**PLANNING COMMISSION
MEETING AGENDA
REGULAR MEETING**

5. PUBLIC HEARING - PRELIMINARY SITE PLAN REVIEW (SP JPLN2021-0028) - Proposed Golden Villas One Family Residential Cluster, South side of Square Lake, West of Dequindre (PIN 88-20-12-200-031 & 88-20-12-200-035), Section 12, Currently Zoned R-1C (One Family Residential) District

6. PRELIMINARY SITE PLAN REVIEW (SP JPLN2022-0002) – Proposed Norton and Quill Site Condominium, Northwest corner of Norton Street and Quill Creek Drive (PIN 88-20-03-251-043 & 88-20-03-251-044), Section 3, Currently Zoned R-1B (One Family Residential) District.

Project Name:	Golden Villas
Plan Date:	February 28, 2022
Location:	South of E. Square Lake, west of Dequindre
Zoning:	R-1C, One-family Residential District
Action Requested:	Preliminary Site Condominium Cluster Approval
Required Information:	Deficiencies noted.

FRONT ELEVATION
SCALE: 1/4" = 1'-0"

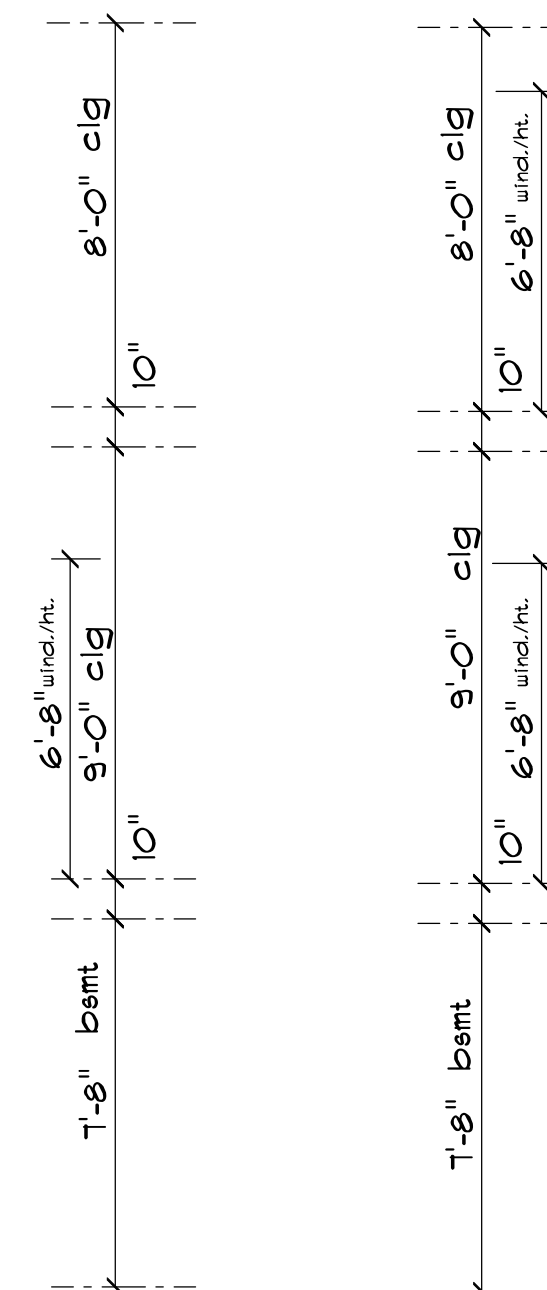
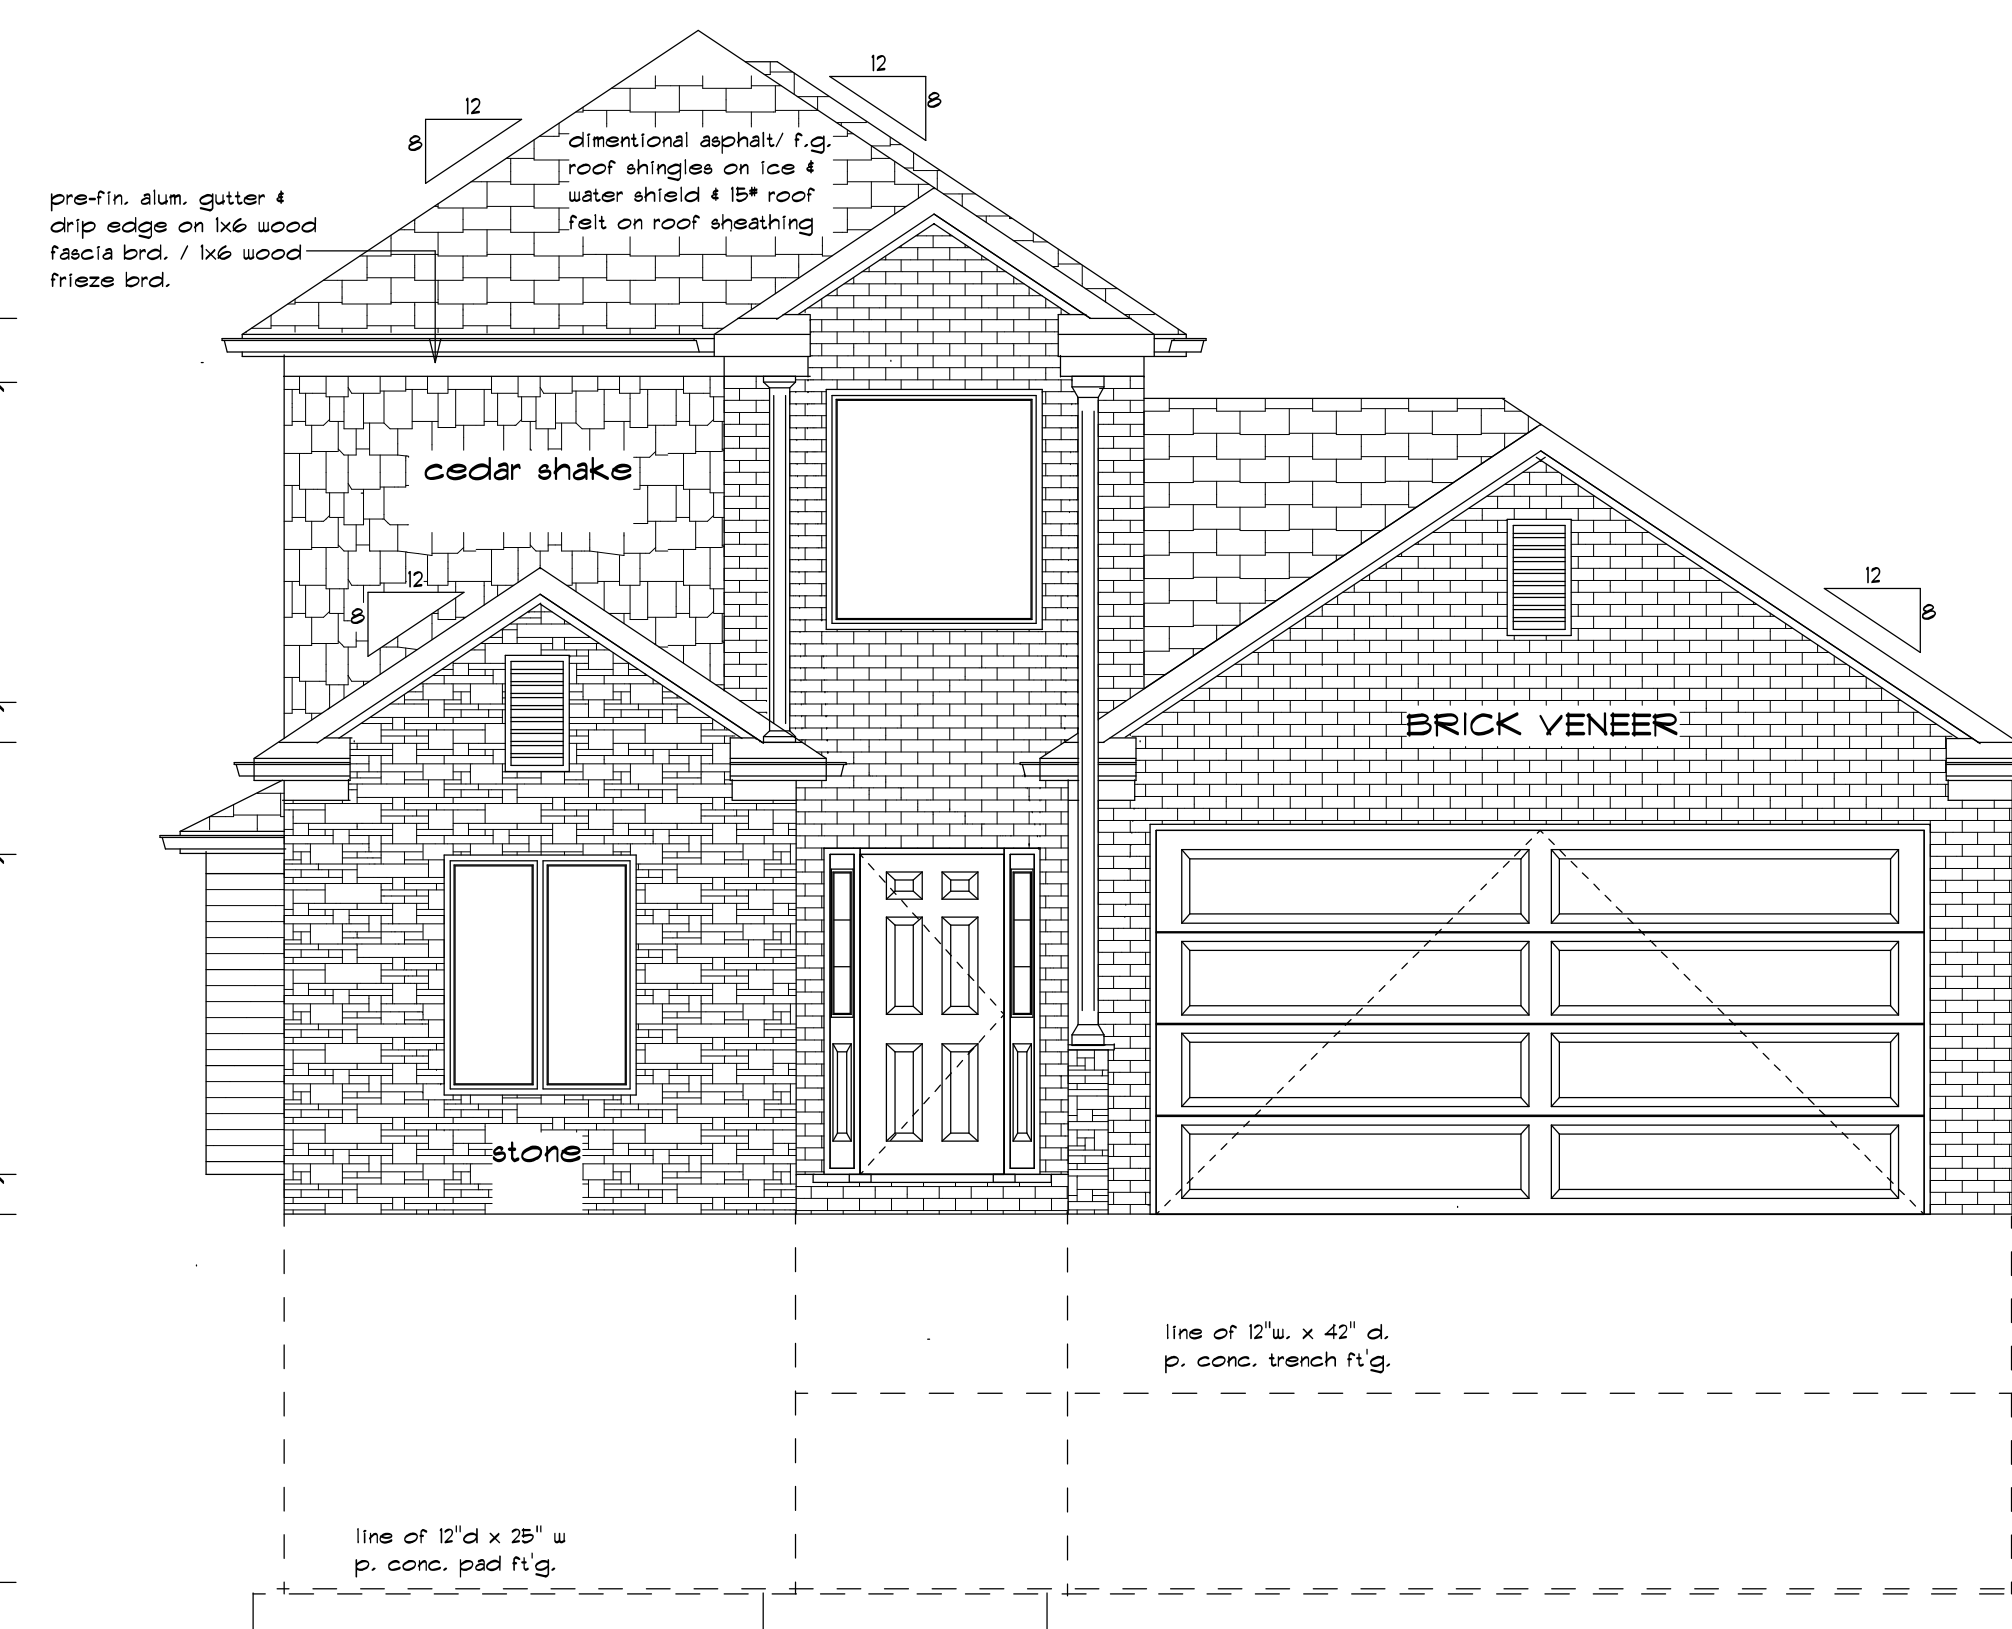
1. Applicant shall provide additional housing elevation options.
2. Applicant shall provide twenty (20) additional trees along Square Lake Road.

Items to be Addressed: Provide additional housing elevation options

Elevation Concept

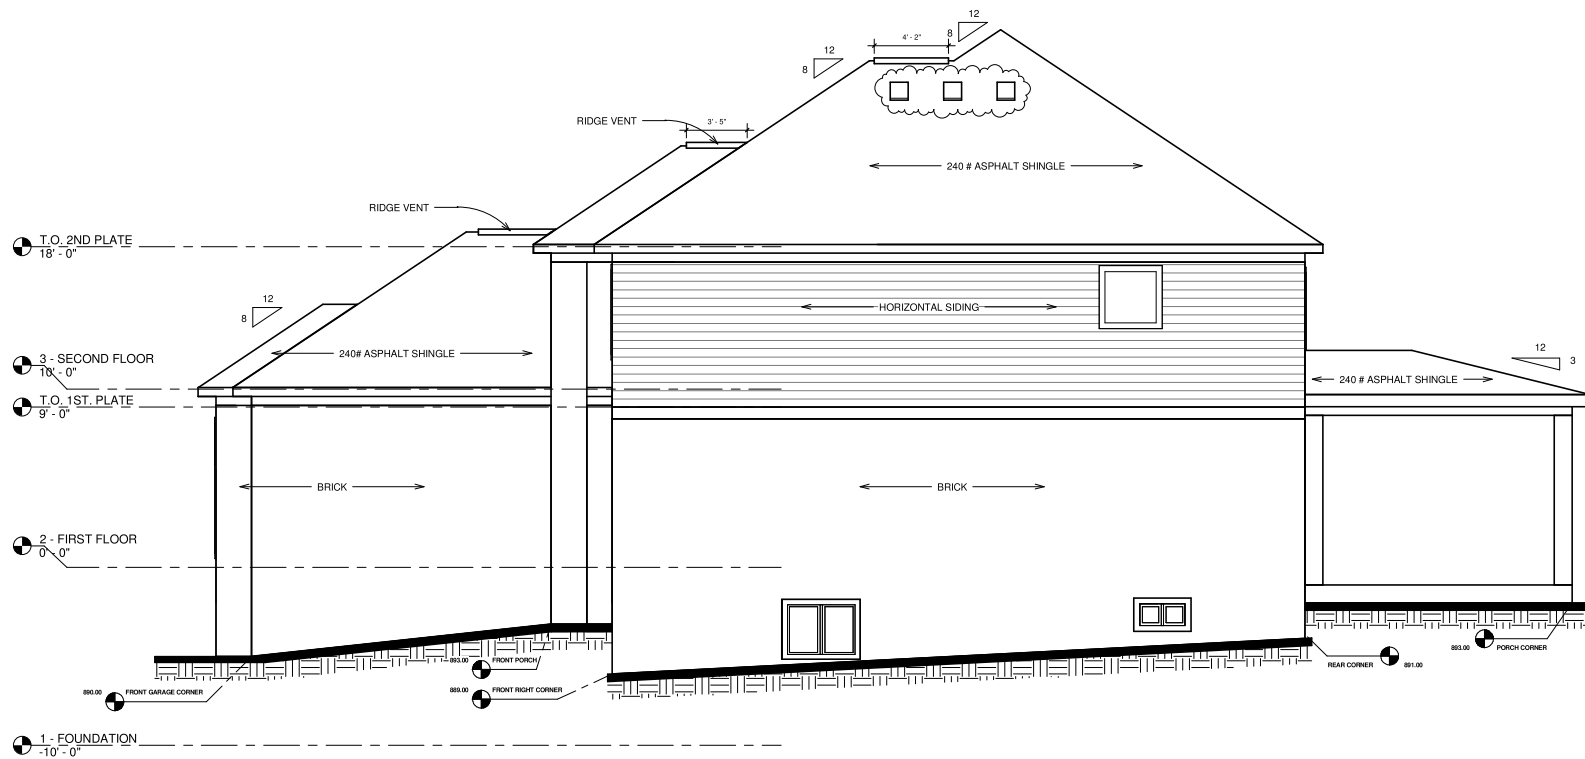
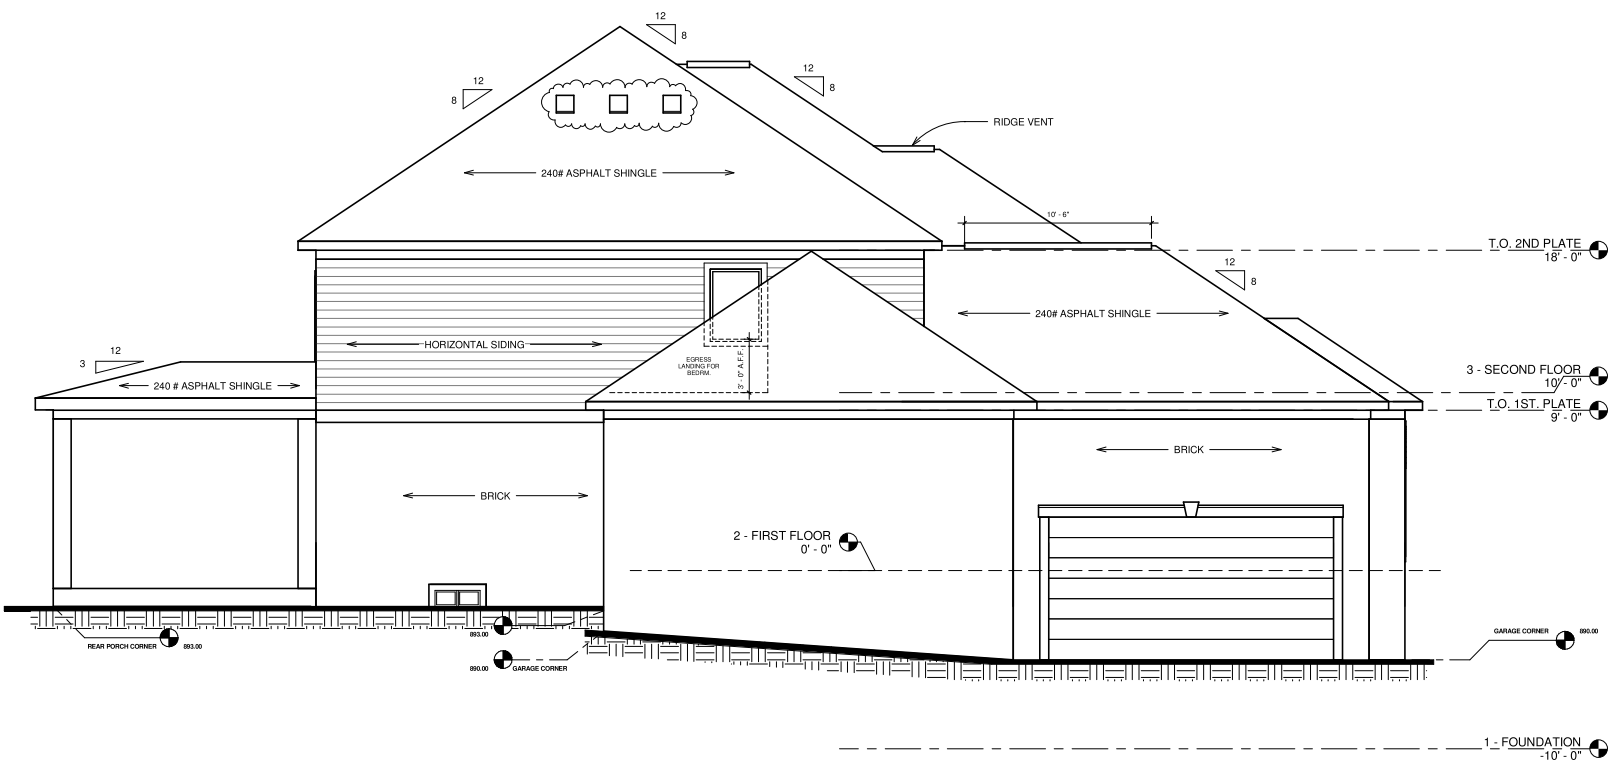
1. Provide tree survey and mitigation requirements.
2. Provide easement for 6443 Norton for City review.
3. Submit revised plan with 45-foot rear setbacks.
4. Have landscape plan prepared by licensed Landscape Architect.
5. Provide elevations of all four sides and provide materials.
